Project	Northern Moor Care Home, Wythenshawe		
Document Number	NMCH-BWB-ZZ-XX-RP-LV-0001	BWB Ref	255809
Author	Peter Leonard	Status	S2
Checked	Steven Walker	Revision	P2
Approved	Peter Leonard	Date	25/09/2025

1.0 INTRODUCTION AND SCOPE

1.2 This Technical Note is in response to Planning Condition 15 which states 'Prior to first occupation of the development a verification report will be required to validate that the work undertaken for the installation of the approved external lighting scheme throughout the development conforms to the recommendations and requirements in the Lighting Impact Assessment prepared by BWB. The report shall also undertake post completion testing to confirm that acceptable criteria have been met. Any instances of non-conformity with the recommendations in the report shall be detailed along with any measures required to ensure compliance with the criteria.'

Scale:	1:100 @ A0	Date:	11.08.25
Drawn by:	DJS	Checked:	JH
Drawing Number:	240327-E-LTG-XX-8000	Rev:	C03
Drawing Status:	CONSTRUCTION		
This drawing is copyright and may not be reproduced either in part or full without written permission from JH Electrical Services.			
DO NOT SCALE OFF THIS DRAWING

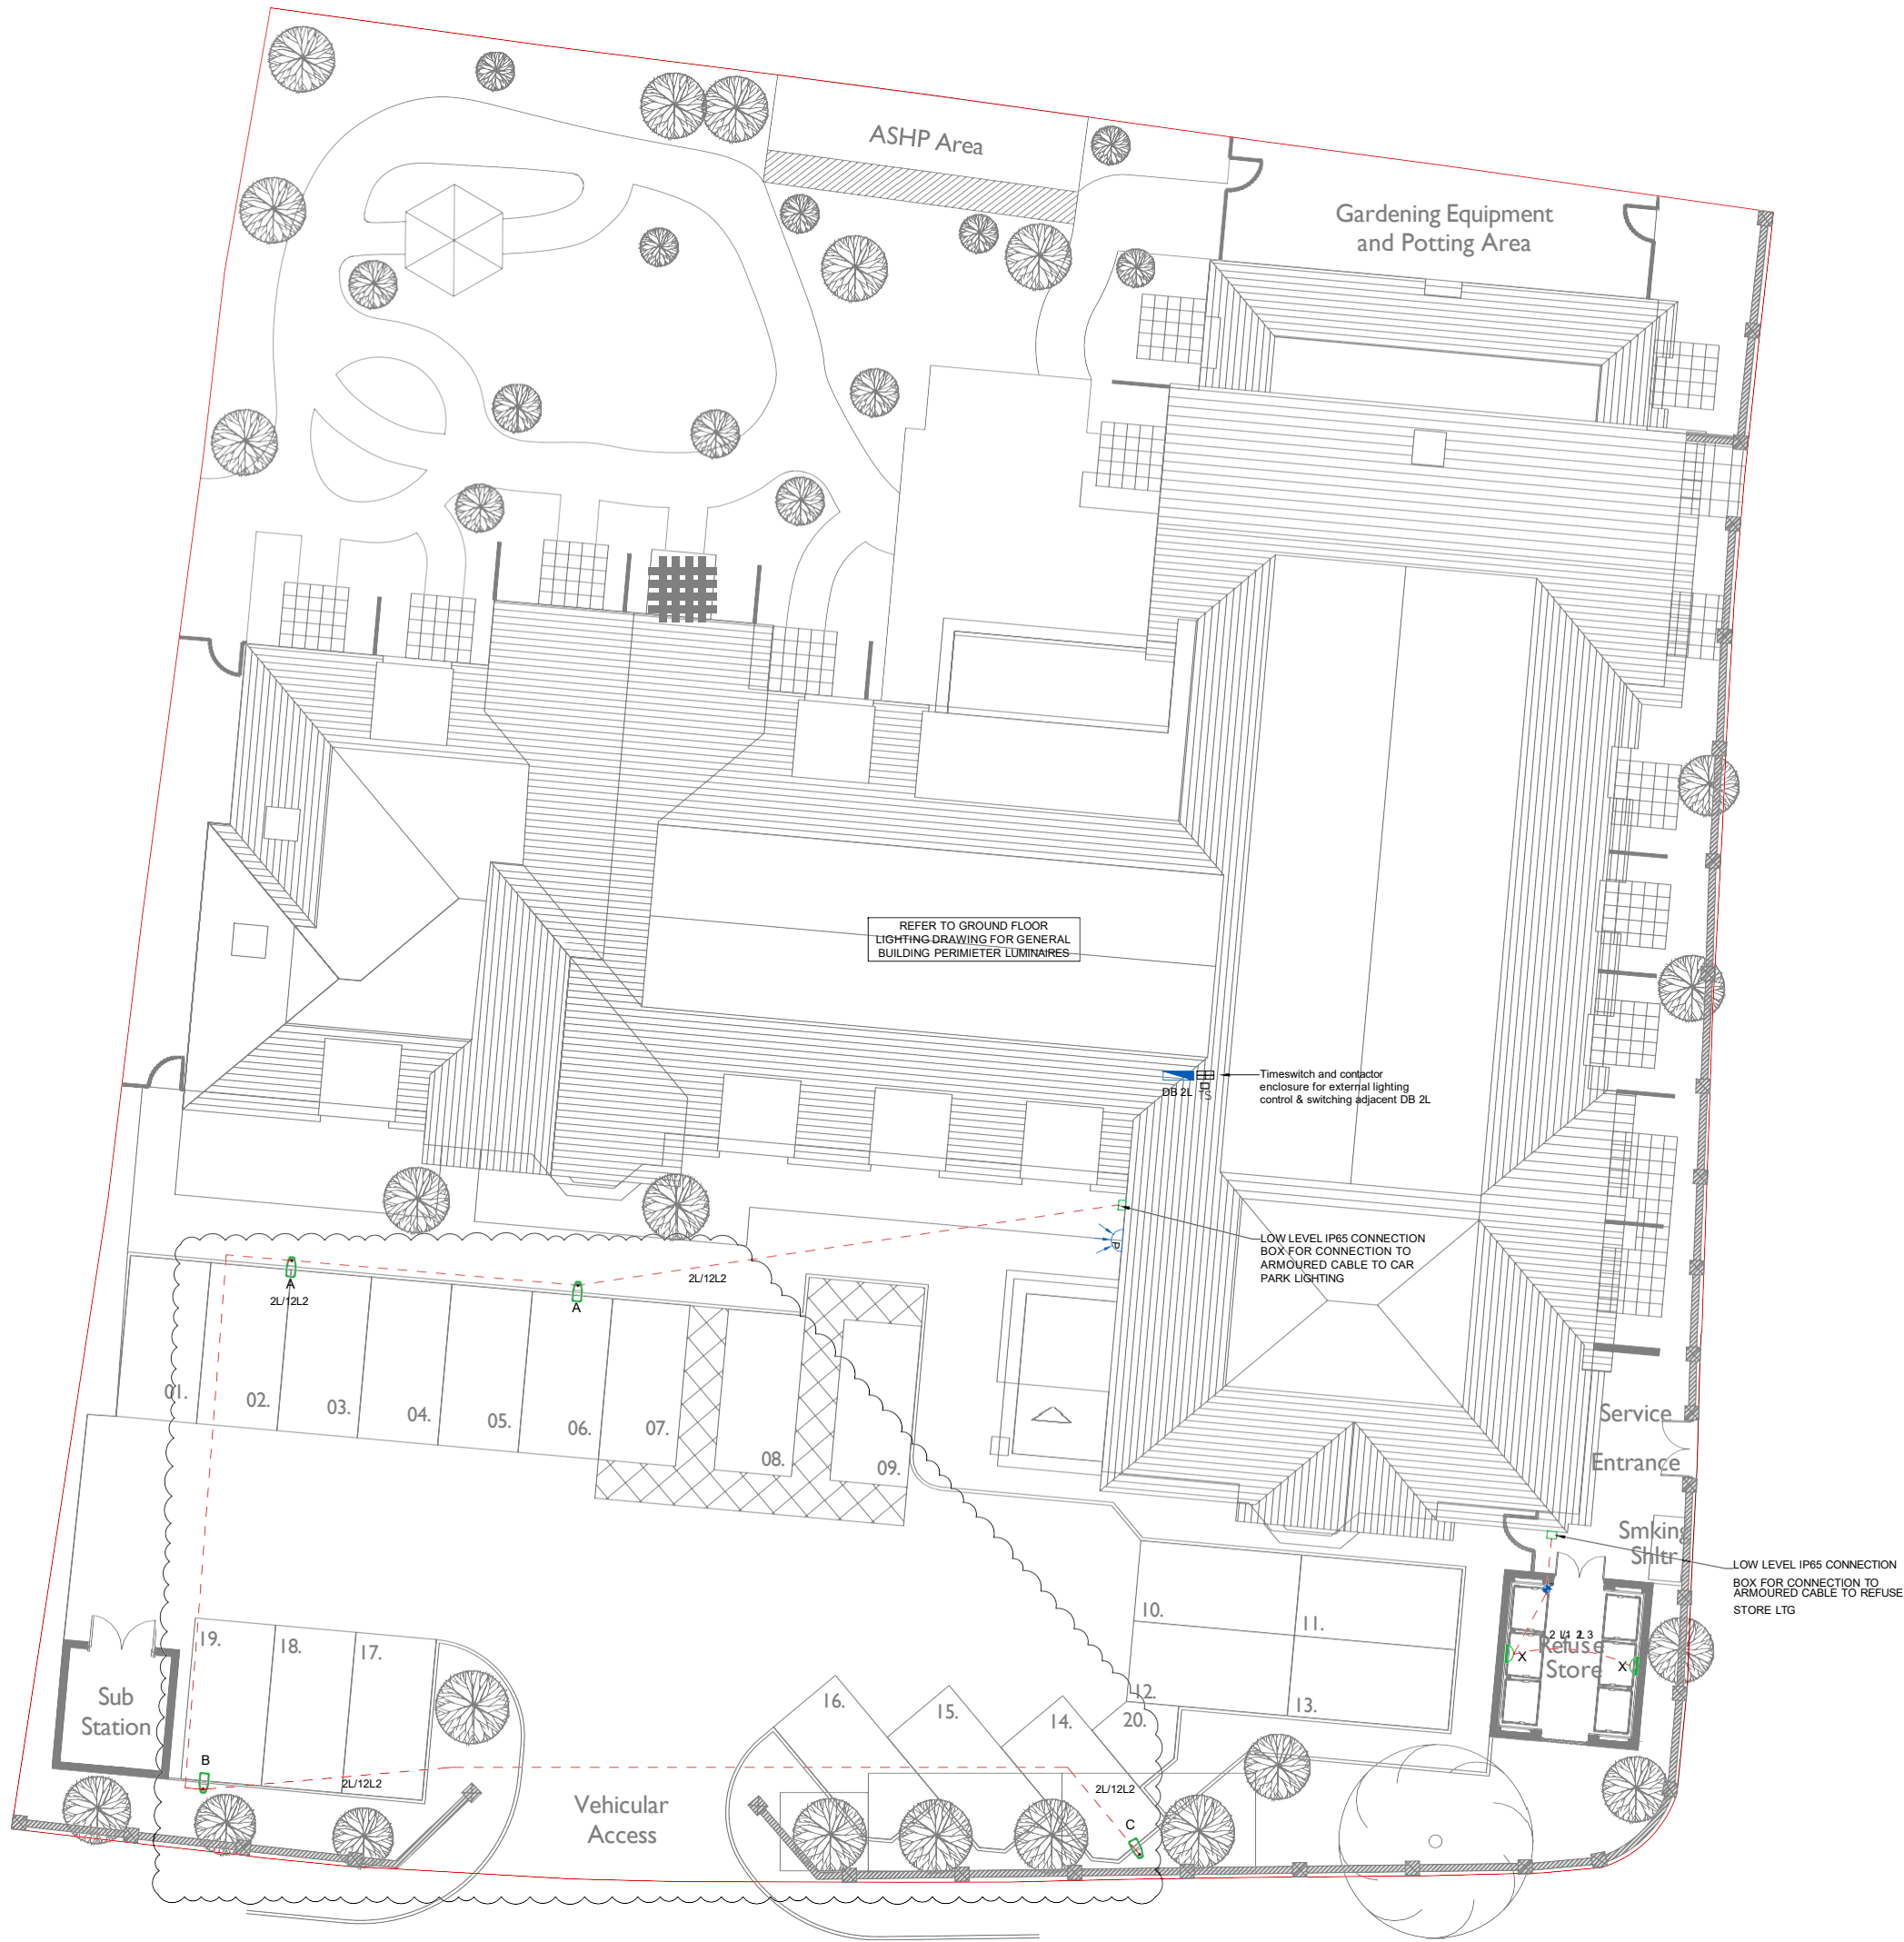
- i. The spill to the residential properties looked higher than the design strategy
 - ii. The spill to the ecology area to the north looked higher than the maximum 2 lux which was agreed with the ecologist

- iii. The colour temperature of the wall luminaires was higher than recommended (2700K vs 4000K) according to ILP GN08 Bats and Artificial lighting at Night

- iv. The colour temperature of the column lights was not indicated on the drawings. These appeared to be 6000K with high blue light component, again significantly higher than the design strategy

- v. The wall luminaires were not the directional type, likely emitting too much upward light to be compliant with ILP GN01 Reduction of Obtrusive Light

- vi. The wall luminaires mounting height appeared excessive
- 5.2 Following our review and comments the below design amendments were agreed and incorporated;

- i. The proposed column mounted luminaires in the submitted design were omitted in lieu of those used in the original lighting design strategy, improving the light spill

- ii. The change in column mounted luminaires also amended the colour temperature to 2700K in line with the original lighting design strategy
 - iii. The perimeter wall mounted luminaires were provided with eyelid attachment to limit direct upward light distribution improving upward light spill and maximising distribution of the useful light to the downward distribution

- iv. The perimeter wall mounted luminaire wattages were reduced in areas, improving the light spill
 - v. The perimeter wall mounted luminaire colour temperature was reduced to 3000K

- vi. The mounting height of the wall luminaires was reduced to a more appropriate level further reducing the light spill

Luminaire Unique Reference	Daytime Photo		Nighttime Photo	
C1				
C2				
C3				
C4

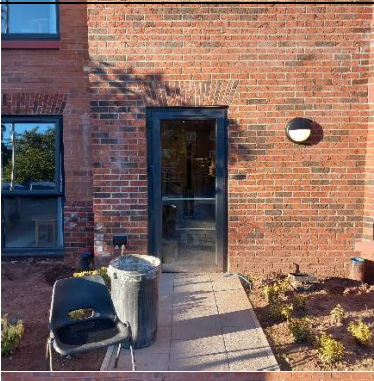
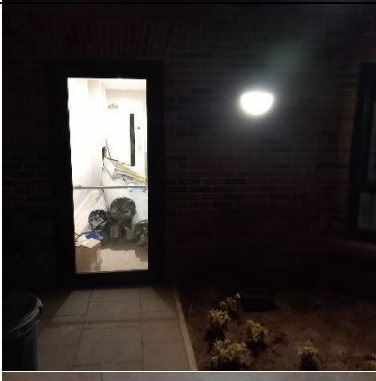
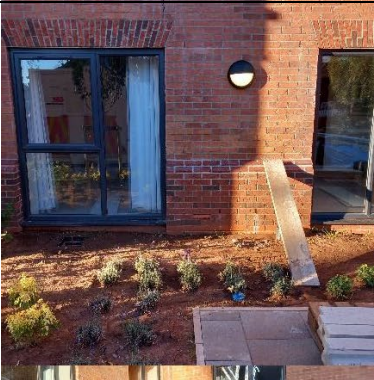
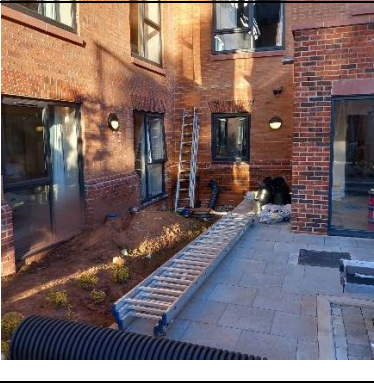
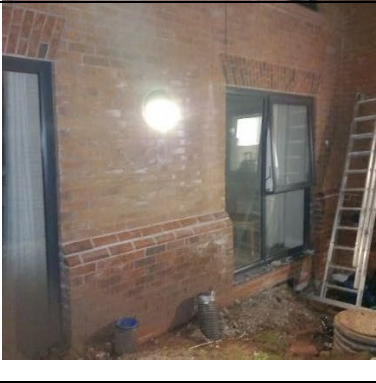
- 5.4 All luminaires were given a unique identification reference for reference as part of the survey which can be found appended to the report.
- 5.5 Column C1 was found to be installed one parking bay east of its position on the design drawings. This actually aligned further with the design strategy and was therefore of benefit to the light distribution. The type, height and orientation aligned with the design

- 5.6 Column C2 and C3 had the incorrect luminaires installed as the lower wattage should have been used at position C3 not C2 and vice versa, the location, height and orientation aligned with the design.

- 6.5 Column C2 and C3 luminaires to be swapped over.
- 6.6 Further mitigation required in the gardening equipment area to reduce any potential impact on any sensitive receptors. The 2 No. wall luminaires in that location shall be reduced to the minimum wattage of 9w.

- 7.5 Column C1 position to be updated on the lighting drawings (and calculations) – Appended to this Technical Note
- 7.6 Column C2 and C3 luminaires to be swapped over – Confirmed completed 09/10/25

W25		
W26		
W27

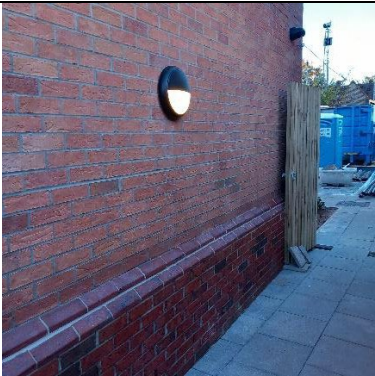
- 5.9 2 No. additional wall mounted (fence mounted) luminaires were identified in the fenced ASHP plant compound. The wattage and colour temperature of these luminaires did not appear to align with the rest of the installation and were in excess of the agreed design proposals.

- 6.1 ASHP compound luminaires W26 – W27 to be added to the lighting drawings
- 6.2 ASHP compound luminaires W26 – W27 wattage to be reduced to the minimum wattage of 9w

- 6.3 ASHP compound luminaires W26 – W27 colour temperature to be reduced to 3000K in line with the rest of the wall luminaires.
- 6.4 Column C1 position to be updated on the lighting drawings (and calculations)

- 7.2 ASHP compound luminaires W26 – W27 to be added to the lighting drawings – Appended to this Technical Note
- 7.3 ASHP compound luminaires W26 – W27 wattage to be reduced to the minimum wattage of 9w – Confirmed completed with photo evidence 23/09/25

- 7.4 ASHP compound luminaires W26 – W27 colour temperature to be reduced to 3000K in line with the rest of the wall luminaires – Confirmed completed with photo evidence 23/09/25
